FINAL WRITTEN SUBMISSION

MELIADINE GOLD MINE NIRB PROJECT CERTIFICATE NO. 006

FINAL ENVIRONMENTAL IMPACT STATEMENT ADDENDUM

**ENVIRONMENTAL ASSESSMENT OF
TREATED GROUNDWATER EFFLUENT DISCHARGE
INTO
MARINE ENVIRONMENT, RANKIN INLET**

Figure 1. Cumulative CP1 Water Discharge to Meliadine Lake between 5 June 2020 and 3 October 2020.

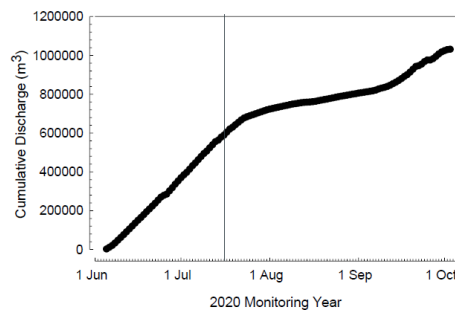
Operation of the waterline at the 20,000 m³/day capacity provides the option to discharge up to 2,400,000 m³ to the marine environment. Agnico Eagle's November 2020 technical memorandum titled "Addendum to 3-D Hydrodynamic Modelling of Melvin Bay to Characterize the Long-Term Mixing and Transport of the Released Effluent" states that "A total of about 3,060,000 m³ of effluent is discharged between June and October," indicating a 5 month potential operational period at 20,000 m³/day.

Even using a 4 month operational period allowing for 20% downtime, Agnico Eagle should have sufficient capacity to both dewater CP1 to the marine environment and discharge the entire saline groundwater inventory to the marine environment annually.

Agnico Eagle may therefore be able to successfully prioritize the discharge of CP1 water into Melvin Bay as soon as the waterlines become available without compromising the integrity of the on-site water management infrastructure.

KIA recommends that Agnico Eagle devote at least 50% of the full waterline capacity (at least 10,000 m³/day) to the discharge of surface contact water to the marine environment as soon as the waterlines become available annually and suspend discharges to Meliadine Lake unless the water levels in CP1 are >94%, the "at risk" CP1 water level for the open water period.
